Gulfstream G280

NUMBER 280-53-287

FUSELAGE (ATA 53) – FUSELAGE – FORWARD
FUEL TANK PROBE CLEARANCE
VERIFICATION

FUSELAGE - FORWARD FUEL TANK PROBE CLEARANCE VERIFICATION

Access Panel Location
Figure 1

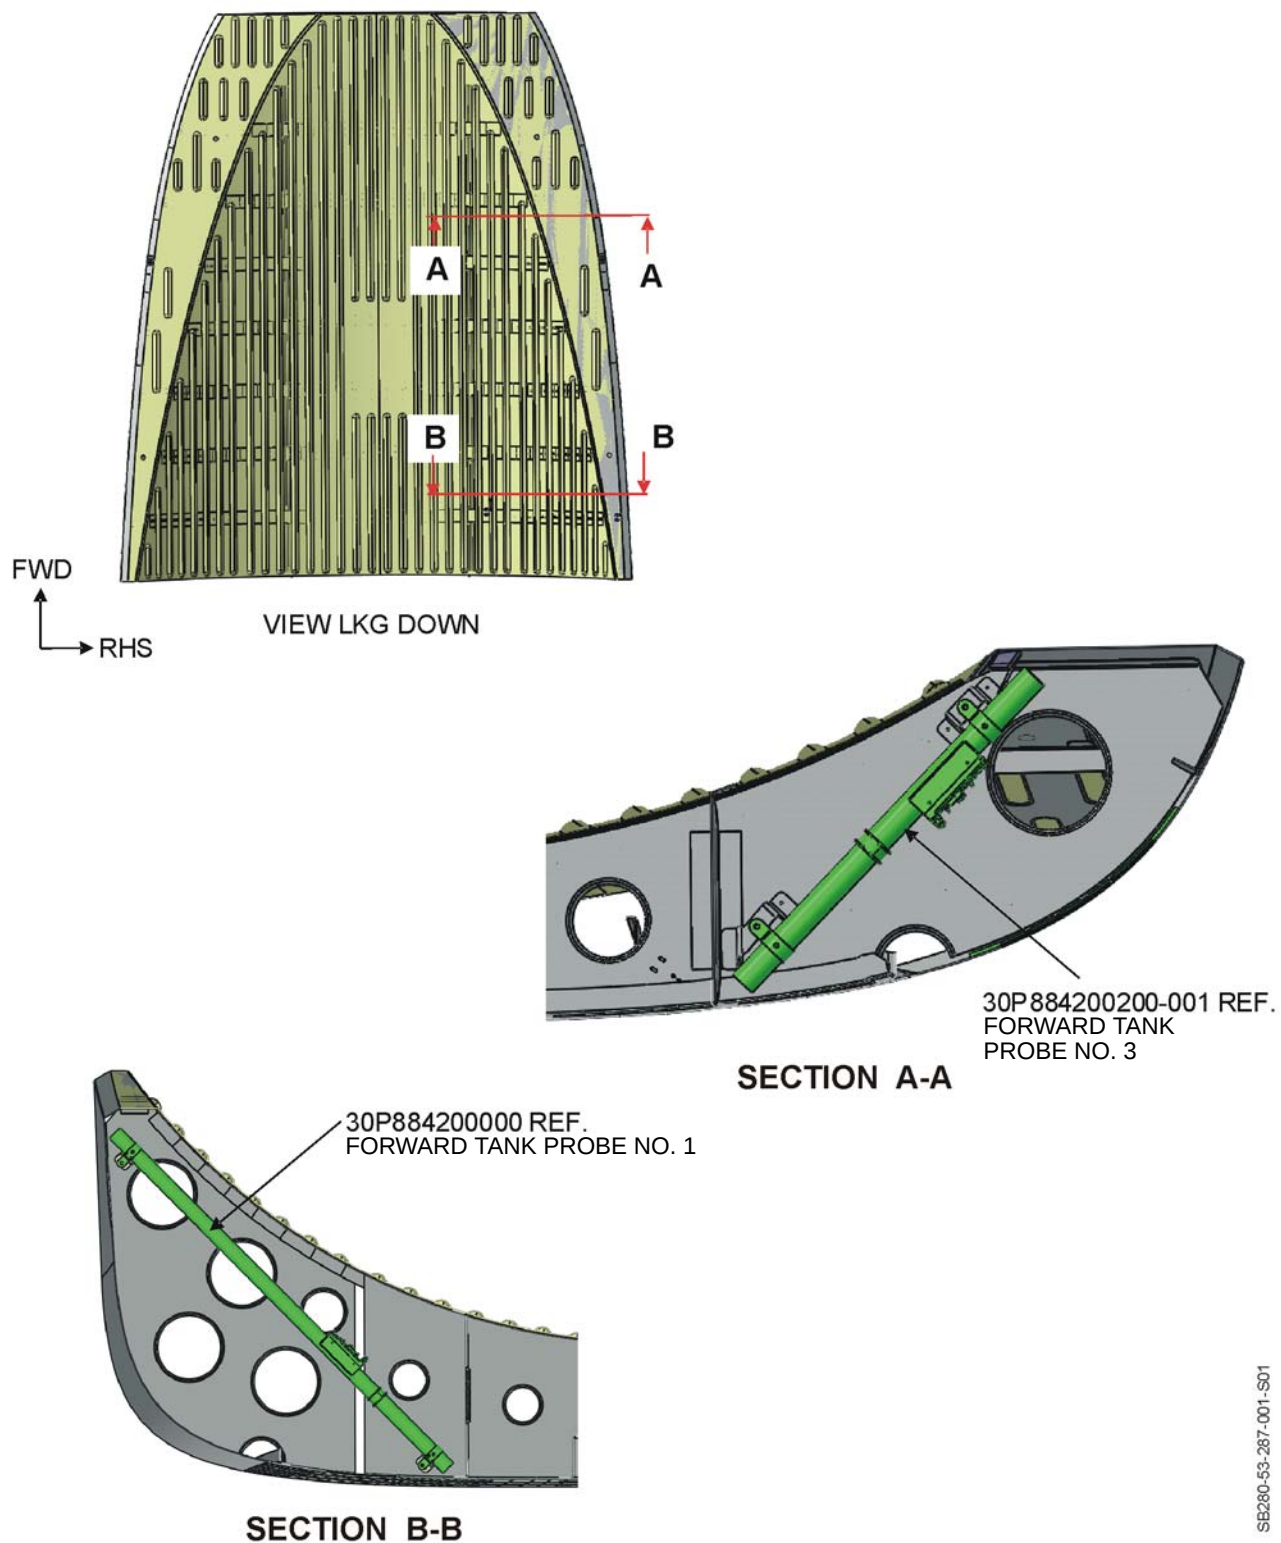
2. Disconnect external electrical power from aircraft. Refer to AMM, Chapter 20.
3. Defuel forward tank if required and drain forward fuel tank. Refer to AMM, Chapter 12.
4. Open forward fuel tank access panels 123BR, 123ER, 123FR and 152DR to access fuel probes No. 1 and No. 3. Refer to Figure 1.
5. Measure the gaps between the probes No. 1 and No. 3 and fuel structure (upper skin, lower skin and stringers).
 - A. If all gaps measured are equal to or greater than 8.0 mm (0.31 inch), proceed to step 9.
 - B. If any gaps measured are less than 8.0 mm (0.31 inch), proceed to the next step for that gap.
6. Remove forward fuel tank probes No. 1 and No. 3 as required. Refer to AMM, Chapter 28 and Figure 2.
7. Install forward fuel tank probe No. 3 as follows:

FWD Fuel Tank Probe No. 1 and No. 3
Figure 2

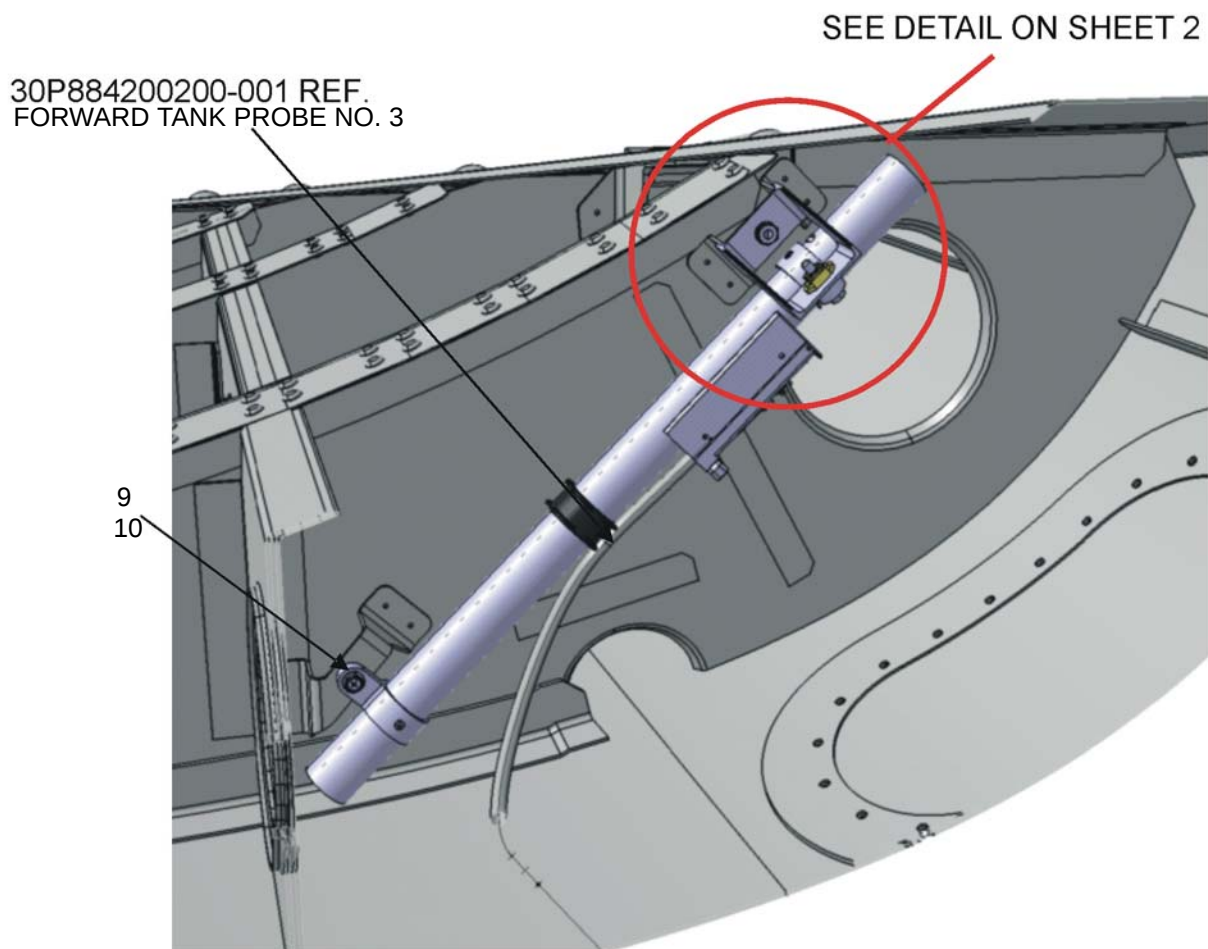
During check of the forward fuel tank it has been found that the distance between the probe to the forward fuel tank structure doesn't meet the minimum 8.0 mm (0.31 inch) requirements (probe No. 1 to the lower skin and probe No. 3 to the upper skin and angle P/N 30P371126800-501).

Probe No. 3 - Installation Rework
Figure 3 (Sheet 1)

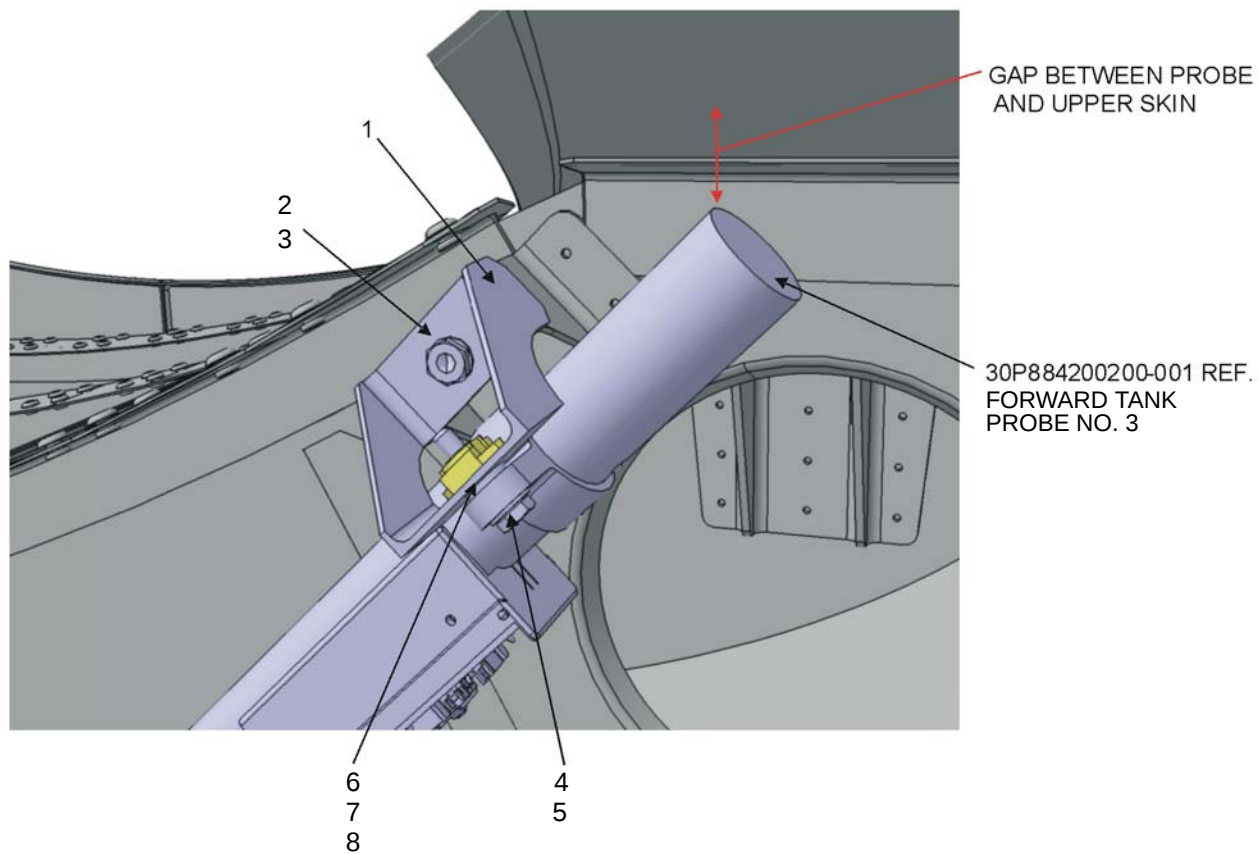
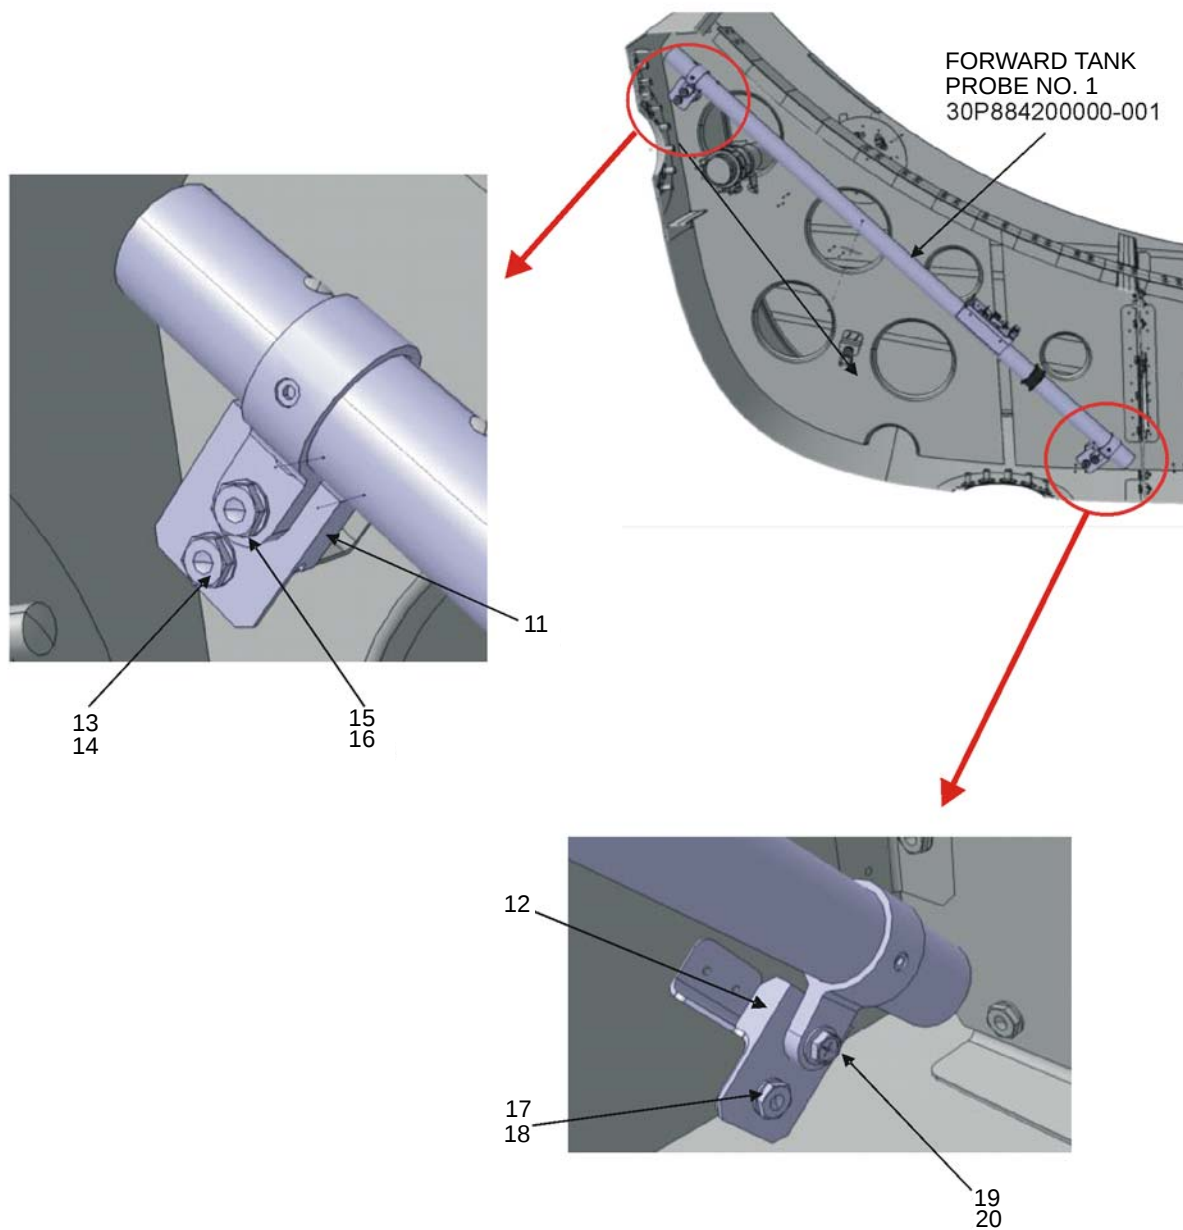
- A. Install sensor bracket assembly, P/N 30P37110008-501A01-509 (1) using flat washer, P/N NAS1149C0332R (2) and bolt, P/N NAS6703U3 (3). Refer to Figure 3.

- B. Install upper part of probe No. 3, P/N 30P884200200-001 on sensor bracket assembly as follows:
 - (1) Install screw, P/N NAS1802-3-16 (4) with flat washer, P/N NAS1149C0332R (5) and adjust the gap between the probe and the fuel tank upper skin to be between 8.0 - 9.0 mm (0.31 - 0.35 inch) using washers, P/N NAS1149C0332R (6), P/N NAS1149C0363R (7) and P/N NAS1149C0316R (8) as required.

- (2) Reinstall lower part of probe No. 3, P/N 30P884200200-001 to its original position using screw, P/N NAS1802-3-10 (9), and flat washer, P/N NAS1149C0332R (10).

- (3) Adjust the forward probe to attain 8.0 - 9.0 mm (0.31 - 0.35 inch) distance from inner surface of the fuel tank upper skin and stiffener, P/N 30P371126800-501.

- (4) Ensure gap between probe and lower skin is equal to or greater than 8.0 mm (0.31 inch).
 - C. Record the measured gaps from steps 7.B.(1) and 7.B.(3).

8. Install forward fuel tank probe No. 1 as follows:
- A. Install sensor bracket assembly, P/N 30P371100008-501A01-505 (11) and P/N 30P371100008-501A01-507 (7) as follows (Refer to Figure 4):

- (1) Install bolts, P/N NAS6703U3 (13), with flat washers P/N NAS1149C0332R (14) and screw, P/N NAS1802-3-10 (15) with flat washer, P/N NAS1149C0332R (16).

- (2) Install sensor bracket assembly, P/N 30P371100008-501A01-507 (7).
 - B. Reinstall probe No. 1, P/N 30P884200000-001 in place using bolt, P/N NAS6703U3 (17) with washer, P/N NAS1149C0332R (18), and screw P/N NAS1802-3-10 (19) with washer, P/N NAS1149C0332R (20).

- C. Ensure gap between the aft probe and the fuel tank upper and lower skins is equal to or greater than 8.0 mm (0.31 inch).
 - D. Record the measured gaps from step 8.C.
